**ADDENDUM NO. 2****DATE:** December 11, 2023**PROJECT:** Pine Street Water & Sewer Relocations
Arkadelphia Water Utility
Arkadelphia, Arkansas**BID DATE:** December 19, 2023, 1:00 PM

**PINE STREET WATER AND SEWER RELOCATIONS
ARDOT JOB NO. 070439**

10 - PLAN - STA 139+00 - 145+00

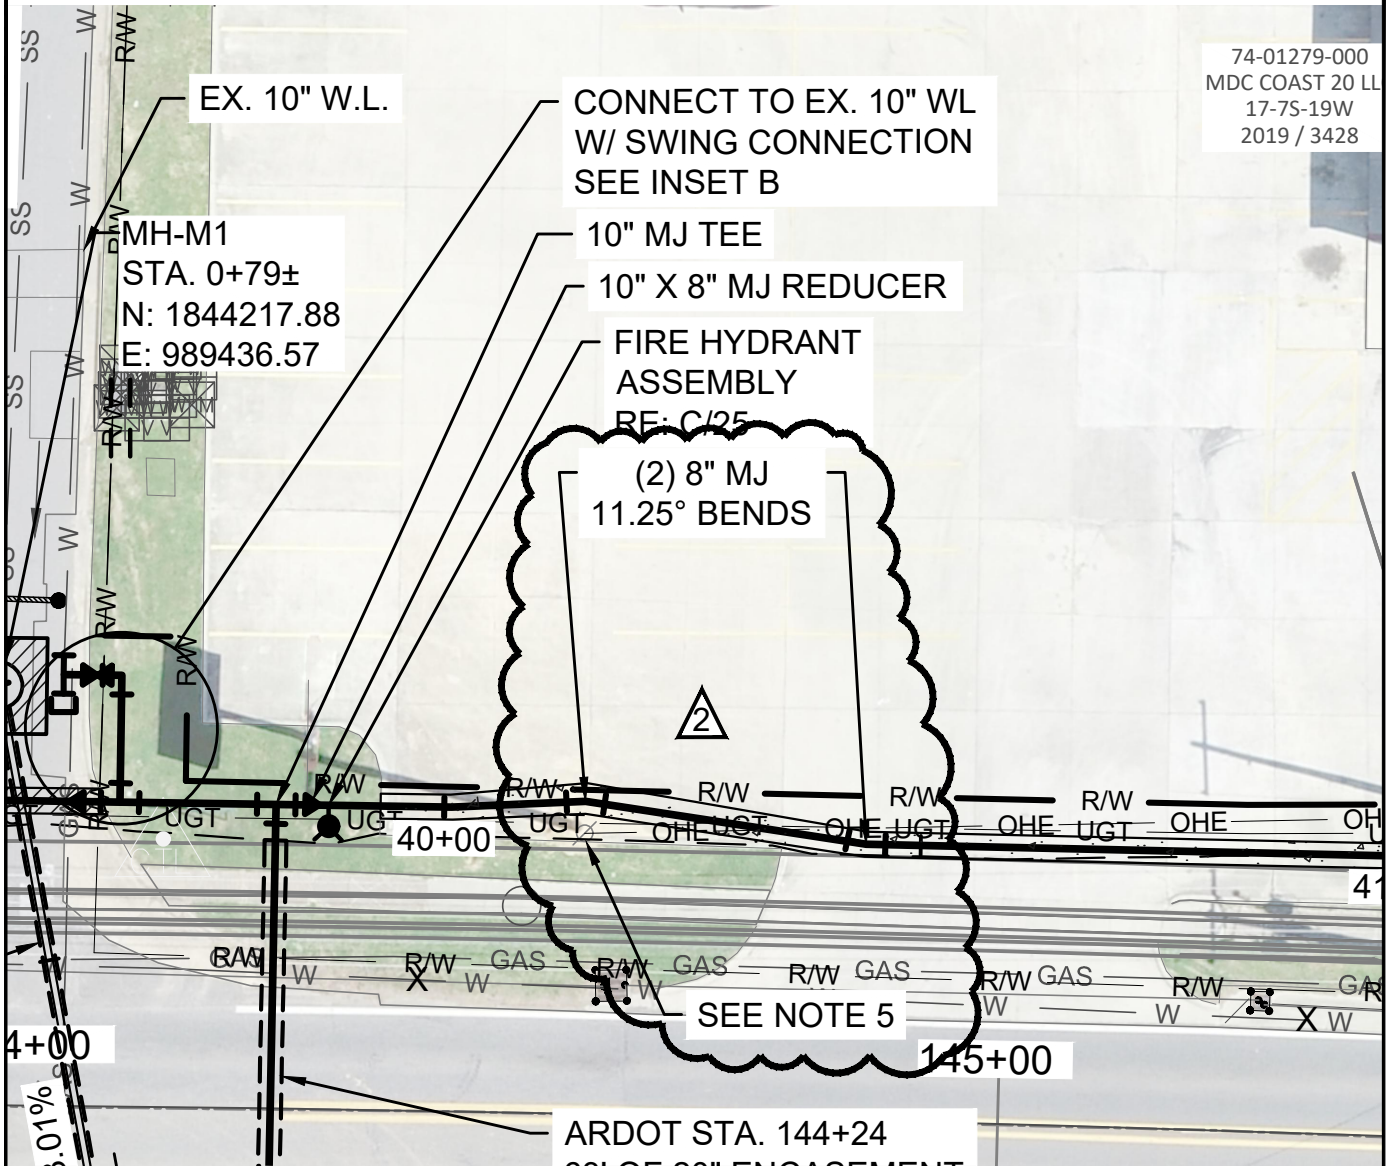
ITEM #9: Drawings – Sheet 10

Modify this drawing as shown on Addendum No. 2 – PLAN – STA. 139+00 – 144+00, attached hereto.

11 - PLAN - STA 145+00 - 150+00

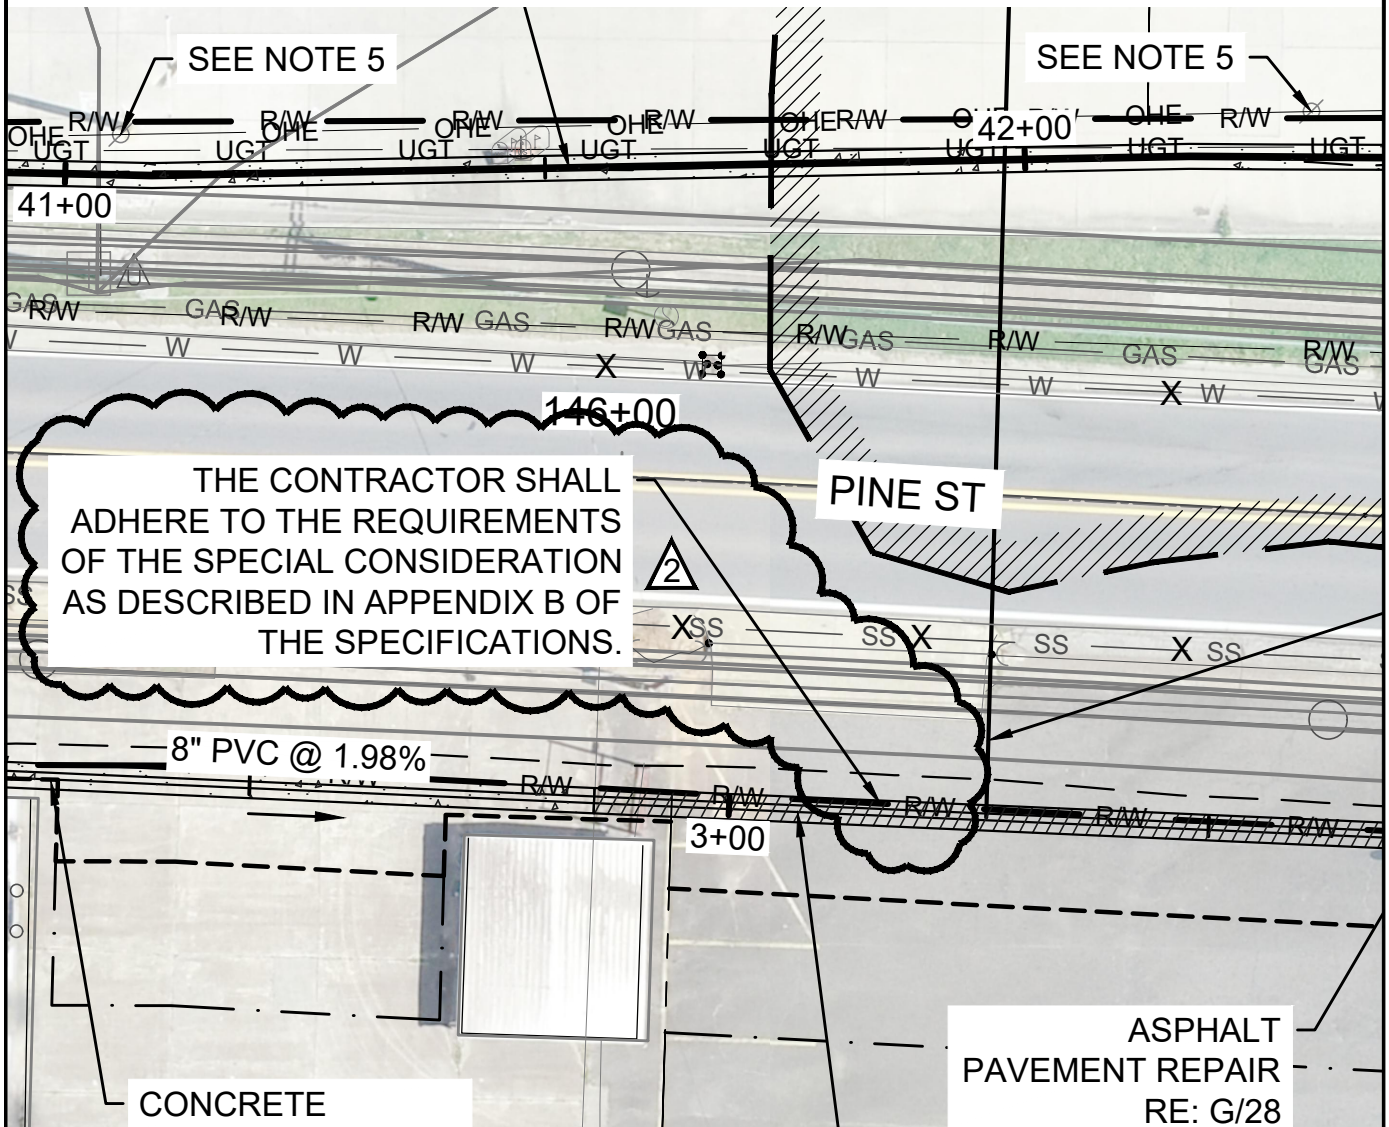
ITEM #10: Drawings – Sheet 11

Modify this drawing as shown on Addendum No. 2 – PLAN – STA. 145+00 – 150+00, attached hereto.
